P-1944
S222
8109
28733

**JINDAL ALUMINIUM LTD.**  
BANGALORE-560073 (INDIA)

PARTY'S NAME	FRICK INDIA LTD., FARIDABAD
PARTY'S DRAWING No.	AS PER PARTYS REQUIREMENT
ALLOY & TEMPER	HE9 WP
DESCRIPTION	INDUSTRIAL MISC. SECTION

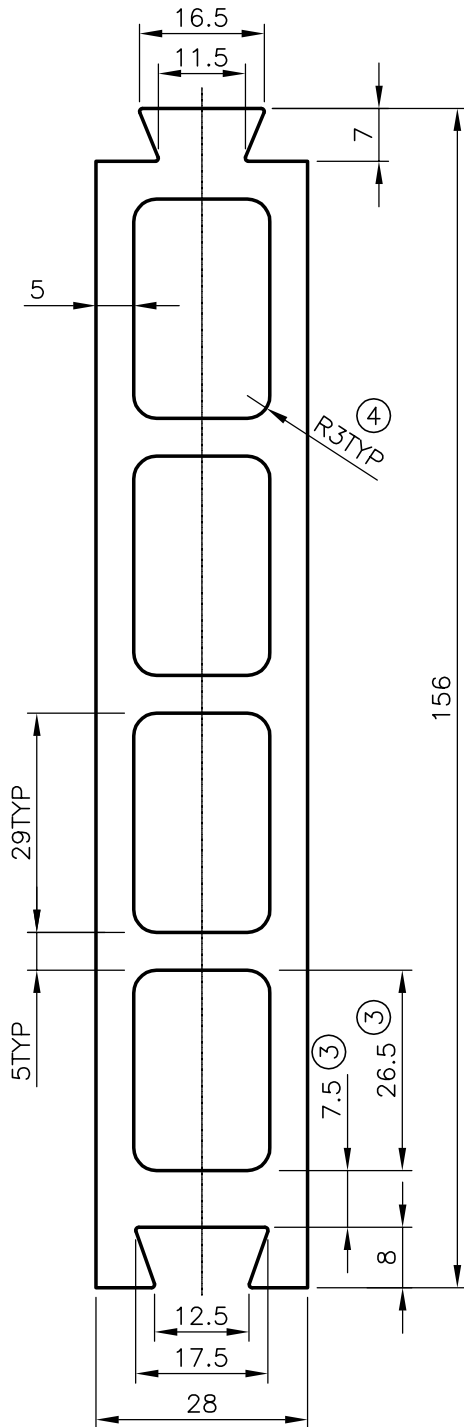
ISSUE-3 DIMENSIONS CHANGED FROM  
05.00 TO 07.50mm  
29.00 TO 26.50mm

& WEIGHT ALSO CHANGED FROM 5.567kg/M TO 5.689kg/M

ISSUE-4 RADIUS CHANGED FROM R0.40 TO R3.00mm

& WEIGHT ALSO CHANGED FROM 5.689kg/M TO 5.772kg/M
